KEYLAN
consulting pty ltd

Oakdale West Industrial Estate Stage 3 (SSD 9794683) – Amended Development Application

1 Introduction

Figure 1: Originally proposed site plan – Building 2A (Source: SBA Architects)

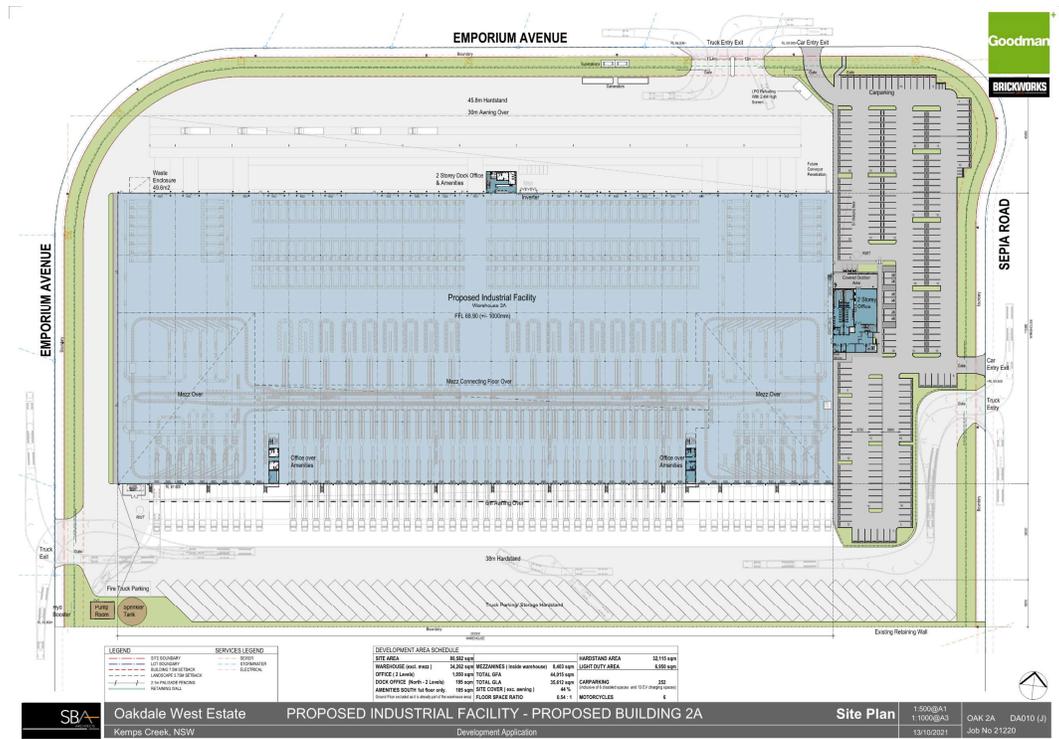
The tenant for Building 2A intends to use the warehouse for parcel processing and distribution. The key proposed amendments to Building 2A include:

- 15% reduction in site coverage (from 58% to 43%)
- 9,738 square metre (m²) (22.1%) reduction in warehouse building footprint (from 44,000 m² to 34,262 m²) and additional 8,403 m² mezzanine

- 2,385 m² (5.1%) reduction in overall Gross Floor Area (GFA) (from 46,400 m² to 44,015 m²)
- 10,788 m² (23.3%) reduction in overall Gross Lettable Area (GLA) (from 46,400 m² to 35,612 m²)

- 1.2 m reduction in ridge height (from 14.9 m to 13.7 m)
- Changed access for car and truck entry/exit points
- Peak traffic generation occurring outside the estate network peak periods of 7 am to 8 am and 5 pm to 6 pm, changing to 5 am to 7 am and 9 pm to 11 pm

- 44 additional car parking spaces (from 208 to 252 spaces) and repositioning of the carpark to the eastern side of the site
- Use of temperature control at the southern dock with units placed on the warehouse roof

Figure 4: Amended site plan providing revised access to Building 2D carpark (Source: SBA Architects)

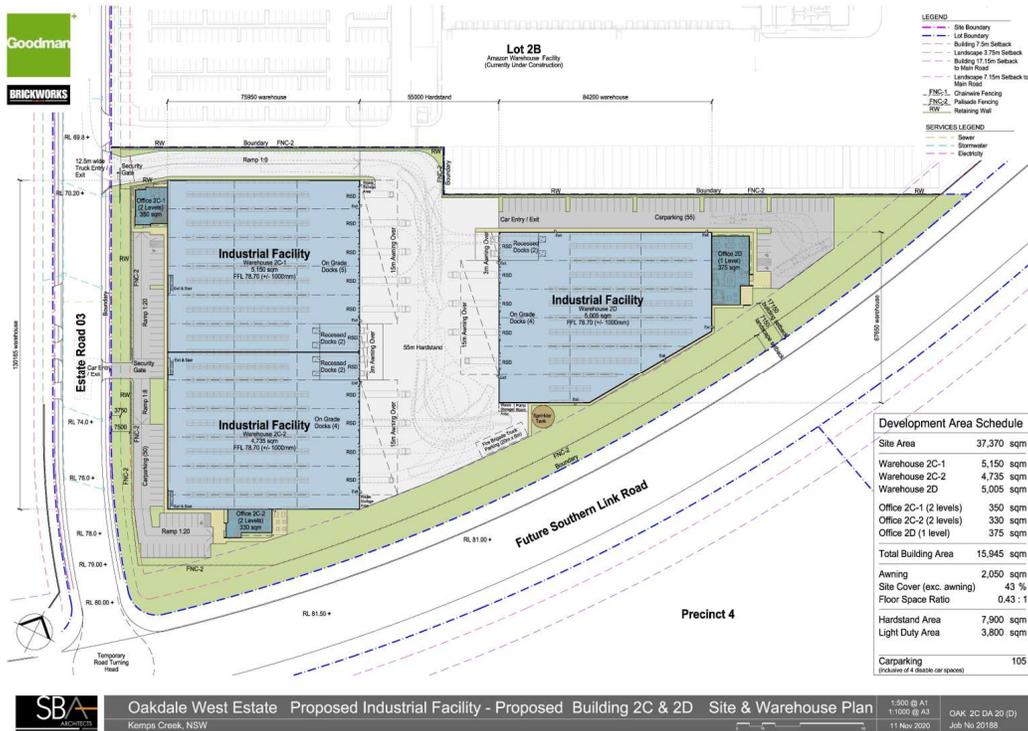
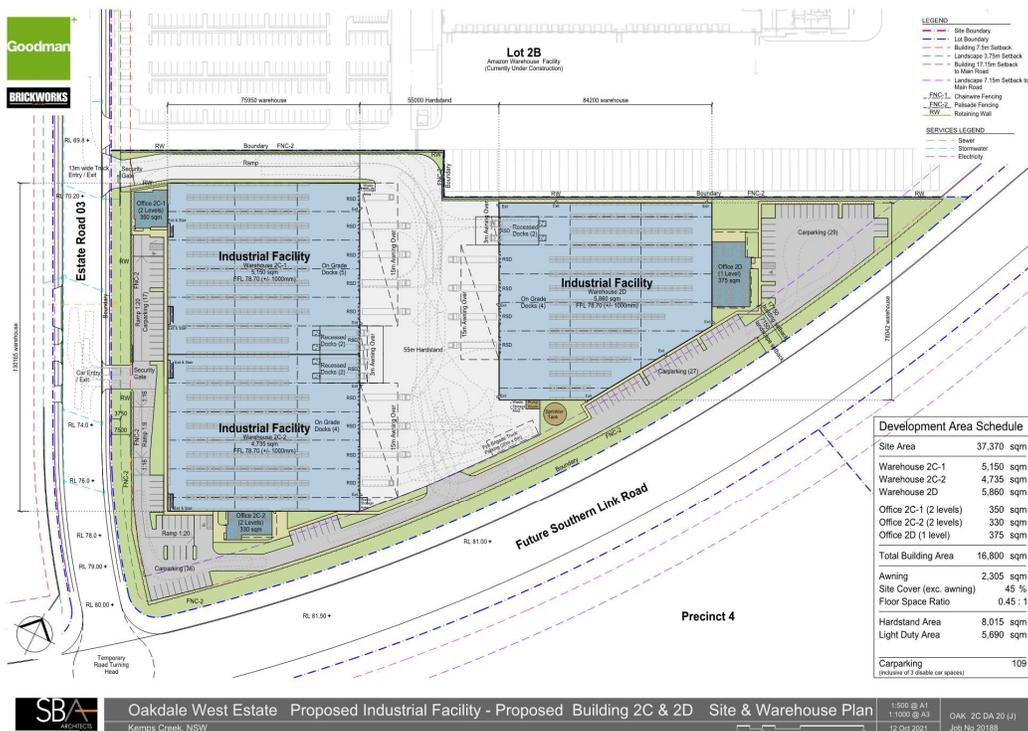
The Department notes that a shared light and heavy vehicle driveway is proposed for access to the Building 2D car park. The Department agrees with Council that this has potential traffic safety impacts along the driveway and within the loading dock area. It is requested that an alternative access arrangement be provided for light vehicles to the car park, noting that landscape setbacks along each boundary must be maintained.

Figure 3 shows the originally proposed site and warehouse plan, with shared access for heavy vehicles and light vehicles accessing the carpark for Building 2D. Figure 4 shows the revised scheme whereby access to Building 2D car parking is provided via the same driveway which accesses parking for Building 2C.

The amended access to car parking for Building 2D reduces any potential for conflicts between truck and car movements. The revised access requires the provision of an access driveway and parking along the southern boundary of the lot. The access driveway does not encroach into any required setbacks, including landscaped.

The Applicant has considered the Department's comments and has amended the proposed access and parking arrangements for Building 2D.

The proposed amendments include a 2% increased overall site coverage (from 43% to 45%) with 3 additional car parking spaces (from 50 to 61 spaces) at Buildings 2C1 and 2C2. The proposed amendments to Building 2D include:

- an 855 m² (17%) increase in building footprint (from 5,005 m² to 5,860 m²) and corresponding 855 m² (16%) increase in overall GFA/GLA (from 5,380 m² to 6,235 m²)
- one additional car parking space (from 55 to 56 spaces)
